Shop Drawing Submittal Review

Project Name: Webster University-**ISB**

Copies	No.	Description
1 PDF	264000E01A	(Submittal No.'s) ~~(R&B CxSRC)~~
		(Cannon #264000-003) - (Paric #15051-0197) – ~~(WES #607)~~
		• **Panel Schedule - Resubmittal**

PANELBOARD RE-SUBMITTAL

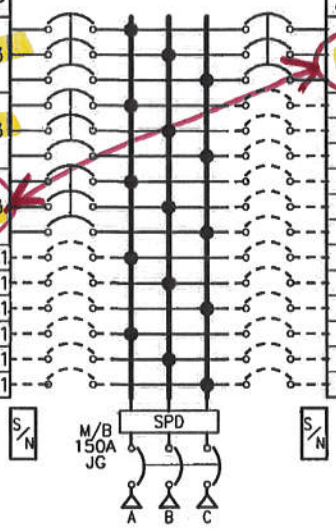
PROVIDE 'SPD'

JOB NAME:	WEBSTER UNIVERSITY ISB	EQUIPMENT DESIGNATION:	4SH1
JOB LOCATION:	WEBSTER GROVES MO	EQUIPMENT TYPE:	NF (Circuit Breaker Type) PANEL 1 OF 1
DRAWN BY:	(Q2C)	DRAWING TYPE:	ONE LINE DIAGRAM
ENGR:			
DATE:	June 13 2016		
DRAWING STATUS:	QUOTE	DWG# 037999262-01	PG 1 OF 2 REV –

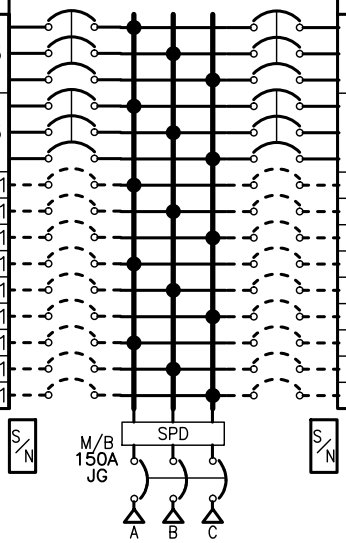
***See attached panel drawings showing the breakers placed per the Tao schedules. Panel 1GH1 cannot have the breakers placed as Tao shows on their schedule so it is not included in this resubmittal.**

Circuit breaker size and position shall match panel schedules on sheets EO503, 504, 505, & 506.

REVISED WITH BREAKERS PLACED PER SCHEDULES
